R610 St. Patricks Junction Improvement Scheme

Stage 1 Quality Audit

July 2026

Document reference: 100287864-MMD-REP-RSA-2026-030 | B

Figure 3.2: Proposed junction layout

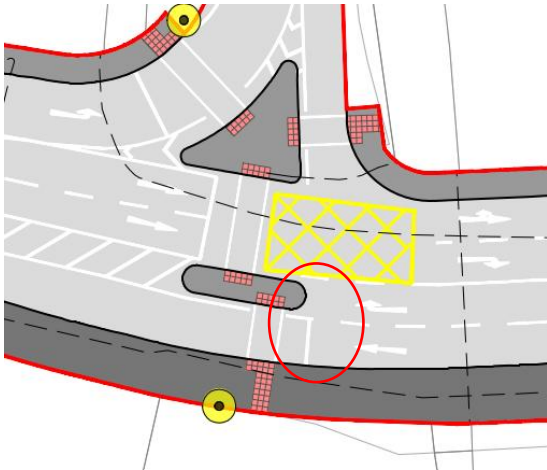
Summary: Right turning vehicles may believe they are uncontrolled and turn at the same time as eastbound traffic potentially leading to turning related collisions.

A stop line has been provided for westbound traffic on Rochestown Road, however right turning traffic is to pass in front of the traffic island. The provision of a controlled pedestrian crossing on the N28 on-slip indicates that the Rochestown Road right turn lane will be required to be signal controlled. However, the presence of the traffic island, potential positioning of traffic signals and lack of a stop line may mislead right turning motorists into believing they are not controlled. Vehicles turning right uncontrolled against eastbound traffic could result in vehicles turning across the path of ahead traffic increasing the risk of collisions. In addition, vehicles may fail to stop for the pedestrian crossing leading to an increased risk of collisions with crossing pedestrians.

Modify the signal-controlled crossing arrangement and associated traffic signal equipment and Stop lines so that the highway arrangement and signal control is clear to all users.

Figure 3.3: Proposed markings within the junction.

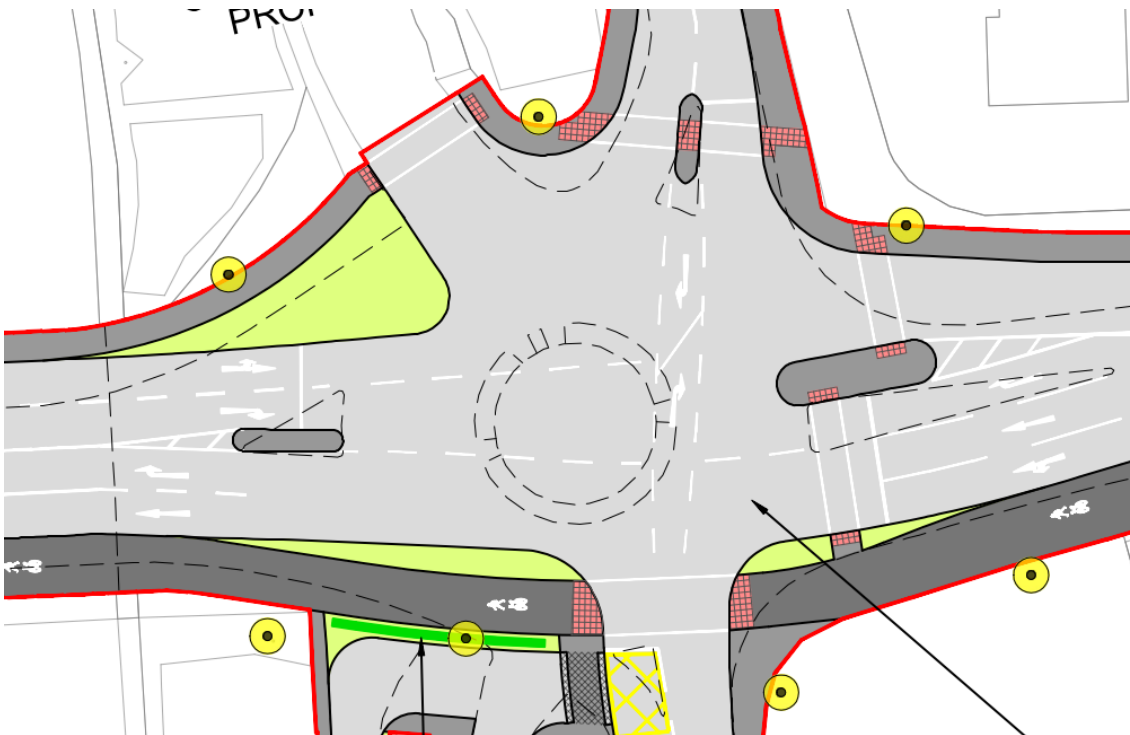
Summary: A lack of clear markings for right turn manoeuvres increases the risk of turning related collisions at the junction.

A number of issues have been identified with the markings within the Rochestown Road, N28 off-slip, Woodbrook and Mount Ovel Junction which could lead to turning related collisions.

- Right turn lanes have been marked out for drivers turning from Woodbrook and Mount Ovel, however these are minor arms with low traffic flows. The markings also extend through the Rochestown Road westbound carriageway and therefore the junction layout may not be clear for other motorists using this junction.
- The right turn lane from Woodbrook guides right turning motorists towards the stop line for eastbound traffic on Rochestown Road.
- No right turn arrow(s) has been shown within the wide right turn lane for Rochestown Road traffic and with the other markings it may not be clear where traffic, particularly from the east, is to wait and turn.

Modify the right turn lanes so that the highway layout is clearly understandable to road users.

Figure 3.4: Proposed pedestrian crossing layout.

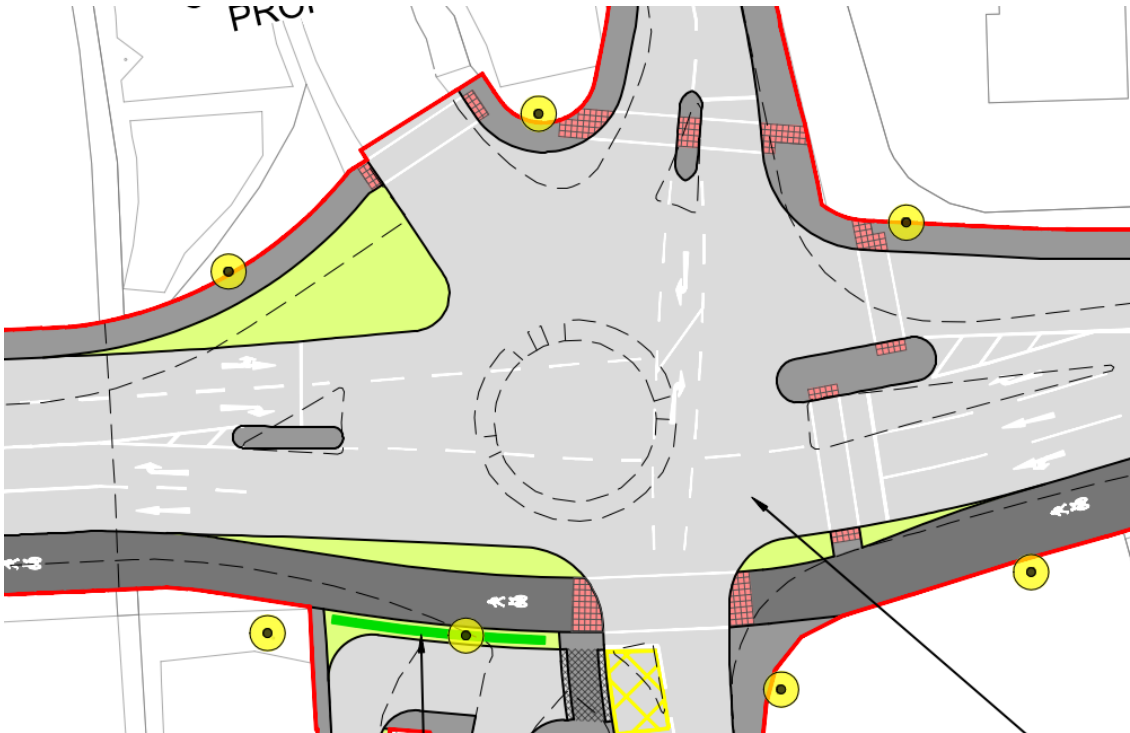
Summary: Incorrect tactile paving may mis-lead sight impaired pedestrians increasing their vulnerability to being struck.

Controlled crossings are proposed over Westbrook, Rochestown Road and Mount Ovel. The tactile paving however is shown in multiple places without the stem which indicates to blind and sight impaired pedestrians that it is a controlled crossing. The lack of a stem may mislead users who may believe it to be an uncontrolled crossing, increasing their vulnerability to being struck by passing motorists.

Provide the correct tactile paving in line with relevant guidelines to reflect they are controlled crossings.

Figure 3.5: Proposed layout at Brookfield.

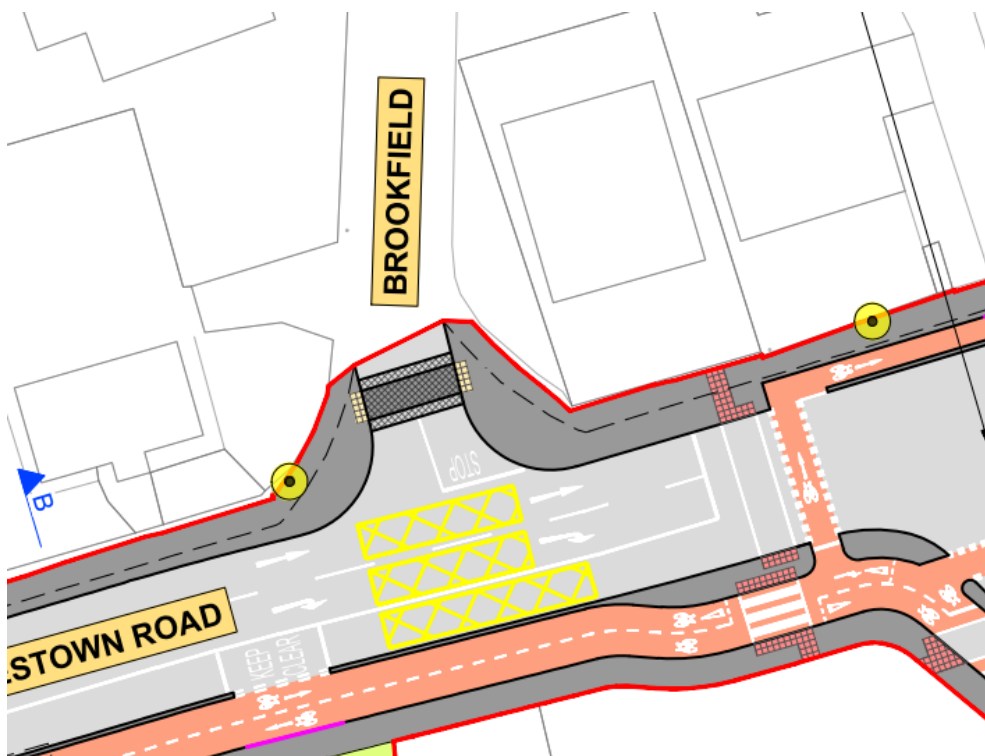
Summary: Lack of cycle provision for cyclists on the northern side of Rochestown Road to access the cycle track may lead to use of the pedestrian or unidirectional cycle crossing potentially resulting in conflict.

Should cyclists from Brookfield on the northern side of Rochestown Road wish to join the segregated cycle track on the southern side of Rochestown Road, they will be required to cross three lanes of traffic and be vulnerable to colliding with motorists. Alternatively, they may use the signalised pedestrian or unidirectional cycle crossing at Clarkes Hill and be at risk of colliding with pedestrians or cyclists.

Provide appropriate links between the northern and southern sides of Rochestown Road, this may involve providing a bi-directional cycle track across Rochestown Road.

Figure 3.6: Proposed cycle track layout at Clarkes Hill.

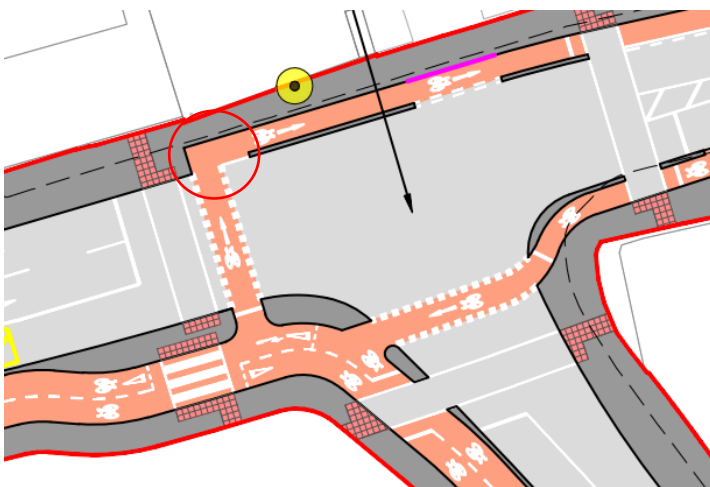
Summary: Sharp turn for cyclists may result in the kerb being clipped or overridden leading to falls from bikes.

Cyclists from the southern side of Rochestown Road crossing to the northern side and heading east are expected to make a 90-degree turn. This sharp turn could be a difficult manoeuvre for some bikes to undertake which could result in the kerb being clipped or overridden. Should bikes strike the kerb, it increases the risk of cyclists being unseated which may result in cyclists falling from their bikes leading to personal injury.

Relax the angle of the cycle track so that it is more gentle and easier for cyclists to turn.

Figure 3.7: Proposed cycle track layout at Clarkes Hill.

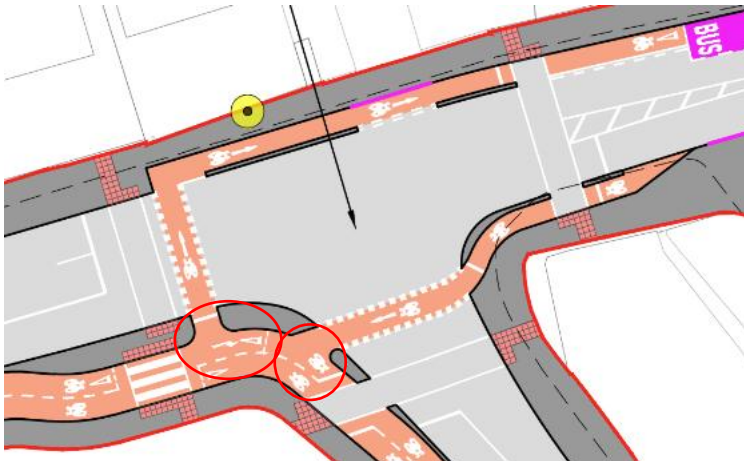
Summary: Insufficient length of cycle track may lead to conflict with other cyclists.

The layout proposes locations where cyclists are to stop or give-way to other cyclists. The Road Safety Audit Team is concerned that cyclists waiting at these Stop and Give-way lines may block the path for other cyclists continuing on a different route potentially leading to conflict between cyclists.

Provide a sufficient length of cycle track for cyclists to wait without hindering other cyclists travelling in a different direction.

Figure 3.8: Proposed arrangement at Clarkes Hill.

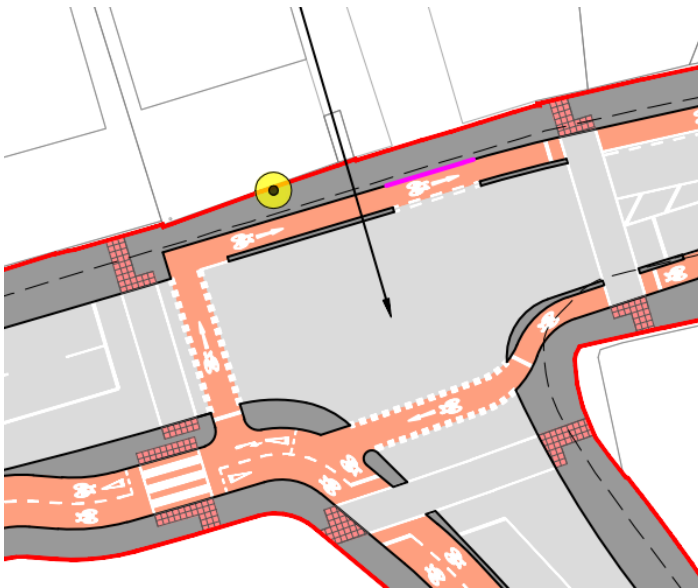
Summary: Lack of control for those properties entering / exiting within the signalised junction could result in rear end shunt and turning related collisions.

Access to several properties is proposed within the signalised junction which do not appear to be controlled. The lack of control could result in motorists exiting the properties into the path of other traffic flows that have a green traffic signal which could result in conflict. Furthermore, through traffic may not expect vehicles to be slowing to turn within the junction leading to rear end shunt related collisions.

Provide signal control for those exiting from Clarkes Hill northern arm. The junction may need formalising and potentially narrowing

Figure 3.9: Proposed Crossings at Clarkes Hill.

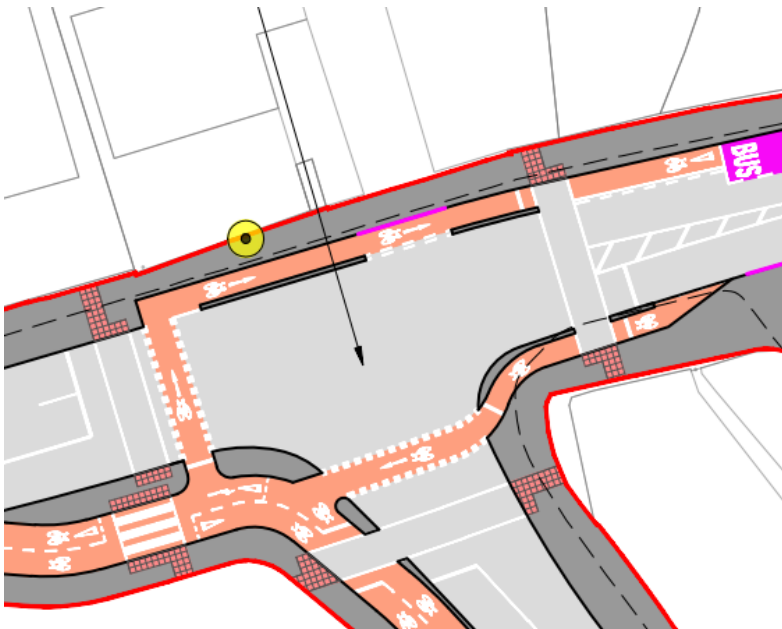
Summary: Lack of appropriate green times for length of crossing may result in pedestrian collisions with motorists and cyclists.

The crossing widths, particularly on Rochestown Road eastern arm and Clarkes Hill are wide taking into account crossing of the cycle track. Should the pedestrian green times not be sufficient in length for pedestrians to complete their crossing movement, it could result in conflict with motorists or cyclists who may commence their movement before a pedestrian has completed their crossing.

Provide sufficient pedestrian green times to allow a pedestrian to fully cross the carriageway and cycle track prior to other signal stages receiving a green light.

Figure 3.13: Proposed layout at Riverside junction.

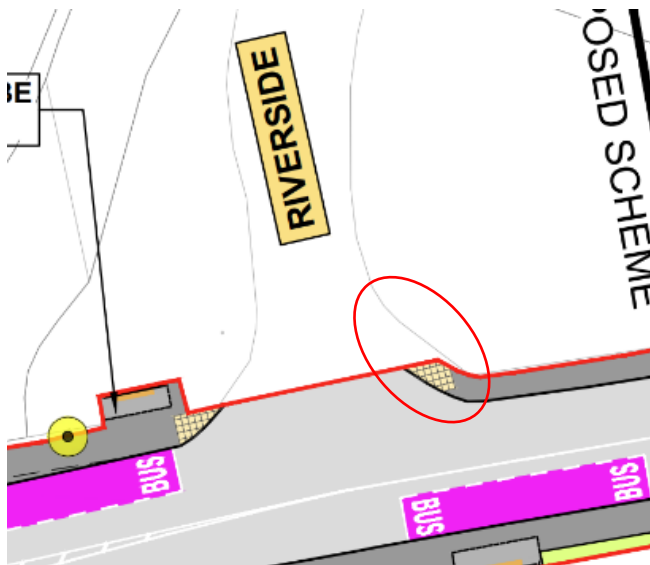
Summary: Inappropriate tie in on Riverside could result in pedestrians walking within the carriageway at risk of conflict with motor vehicles.

The kerb alignment is to be amended, however it is not clear how the kerb is being modified and connecting with the existing provision on Riverside. Should the proposed footway fail to connect with the existing footway provision it could result in pedestrians being within the carriageway at risk of conflict with motorists.

Continue the footway from Rochestown Road into Riverside.

Figure 3.14: Proposed bus stop opposite Riverside.

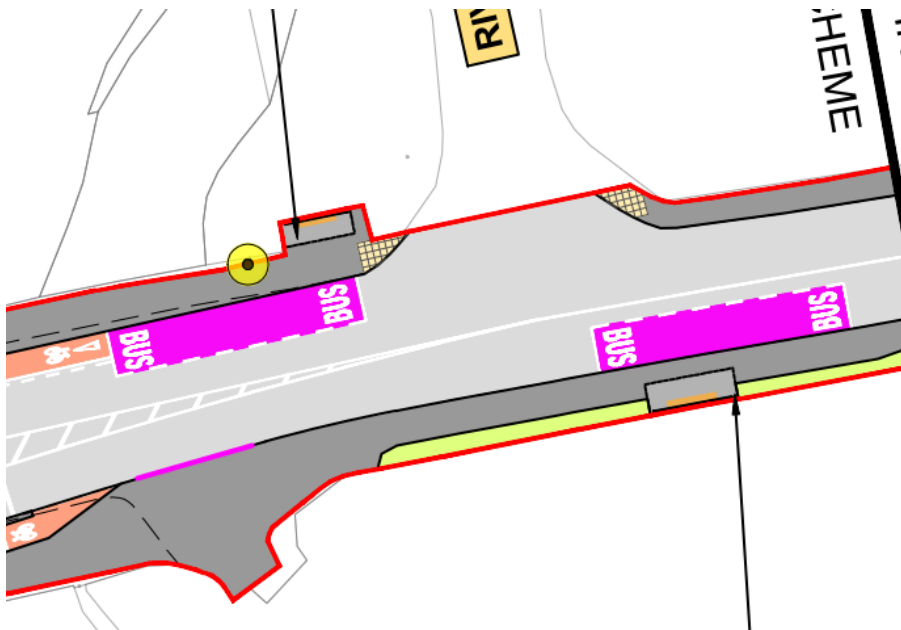
Summary: Bus stop opposite junction may lead to vehicles overtaking a bus at the same time a vehicle exits Riverside leading to turning related collisions.

The bus stop on the southern side of Rochestown Road is proposed almost opposite Riverside. There is concern that a westbound vehicle on Rochestown Road may attempt to overtake a stationary bus at the same time a vehicle pulls out of Riverside, increasing the risk of turning related collisions.

Relocate the bus stop further away from the junction.
